## LPCXpresso55SXX.PrjPcb

Elaborated by: Eduardo Teofilo Checked by: José Ogando

Revision: A2 Last revision date: 5/29/2019

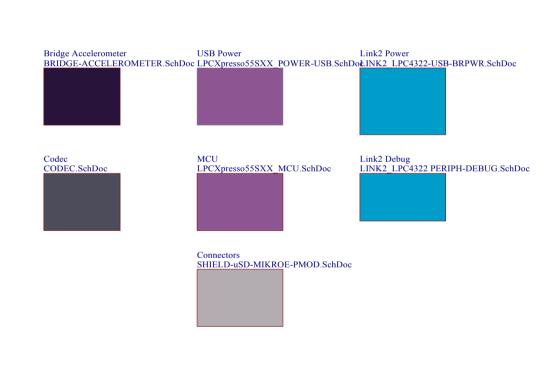
**Change Log** 25-04-2018 Power supply of Link2 circuitry replaced from 3.3v to 2.5v
 Package of LPC5500 changed from BGA to HLQFP - Added 33Ohms Resistor for DP and DM pins of USB0 FS - Added TestPoints for U2 debug signals 08-05-2018 - Tied P0\_5 to P7 Pin7 - SDO Pull-ups tied to VDD\_SD - Added Pull-up for P0\_5-ISP1 - Added notes and descriptions - Added jumper to P25 Added connections to P19
Added debug probe for U2 Removed P22 Debug probe for U1 - Changed Y3 form 12MHz to 16Mhz 16-05-2018 Removed external battery support - Added Support for 1.1v external power supply 21-05-2018 - Exchange of functions between PIO1\_5 and PIO1\_7 25-05-2018 -Changed function of PIOO\_15, PIOO\_18, PIOO\_22, PIOO\_28 and PIO1\_13 -Added Cpacitors C97, C100 -Fixed values of R82, R86 -Changed PN of U8, U9, U10 -Removed U4 31-05-2018 -Changed P14 2X1 to 2X2 header 1-06-2018 -Removed U17 6-06-2018 - Added P28 29-08-2018 - Changed U10 XC6504A251MR-G to XC6223H251MR-G 05-11-2018 -Added P29, R85 05-11-2018 -L10 Replaced from CBC2518T4R7M to TDK MLZ2012M4R7HT000 15-11-2018 -R120 and R121 were changed from 100K to 2.2k -Fix SDA connections -Updated Revision to A1 -Added LPC55S69 and LPC55S28 variants -Changed J11, J12, R73, R114, R128 to DNI -Restore P20 to variants 29-05-2019 -Changed R74 from 100K to 330K -Added variants to silk screen -Updated Revision to A2
